DRAINAGE REPORT CHECKLIST

RE: RACQUETBALL COURTS FOR ROSS ARAGON DRAINAGE REPORT, MARCH 1981 F-18-D20

RE: DRAINAGE REPORT - RAQUETBALL COURTS FOR ROSS ARAGON

RE: RACQUETBALL COURTS FOR ROSS ARAGON
DRAINAGE REPORT DATED AUGUST 5, 1981

SITE PLAN / DRAINAGE PLAN

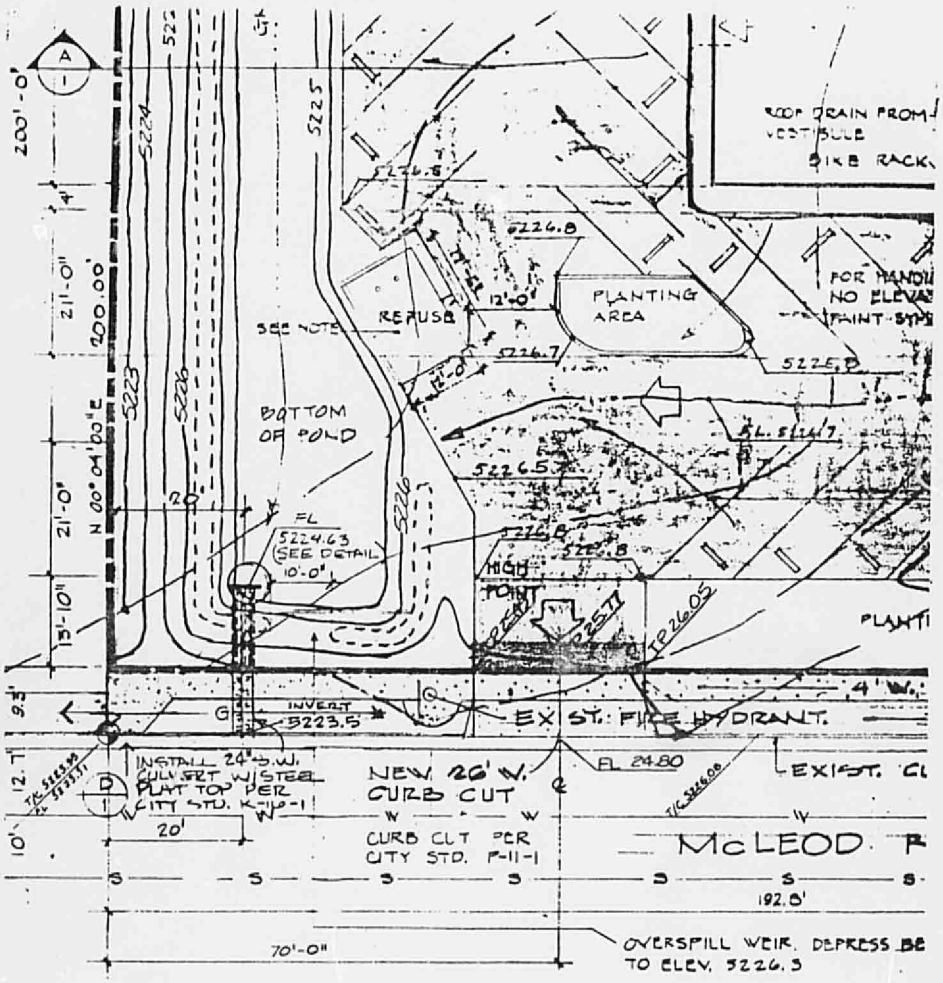
(3) ALSO, SEE COMMENTS IN RED ON THE GRADING PLAN.

2. Cross-sections along a portion of the north property line to evaluate the proposed grading with respect to retaining wall requirements. This item was indicated in red on the grading and drainage plan mailed to you on June 16, 1981.

1. A spot elevation at the north inlet to the pond.
2. A completed Covenant Agreement.
3. A completed Special Order 19.
4. The specifications for the construction of the berm.
5. The drivepad elevations at the south east corner per City standards.
6. A detail of the pond outlet (recommend header curb at the pond outlet).

4. Pond Safety - the free storage of the pond has been reduced to 1.5 feet. 0.75' of gravel has been called out to be placed in the bottom of the pond. See the grading and drainage plan for the actual pond volume calculations and gravel specs.

6. Roof drainage has been indicated on the plan.

7. Reference is made to City Standard Drawing P-11-1 for drive pad construction. Flows line elevations and elevations at property line have been added to the plan at the center of drive pads.

10. East property line slope has been modified by the addition of a railroad retaining wall. Maximum slopes are now 2:1.
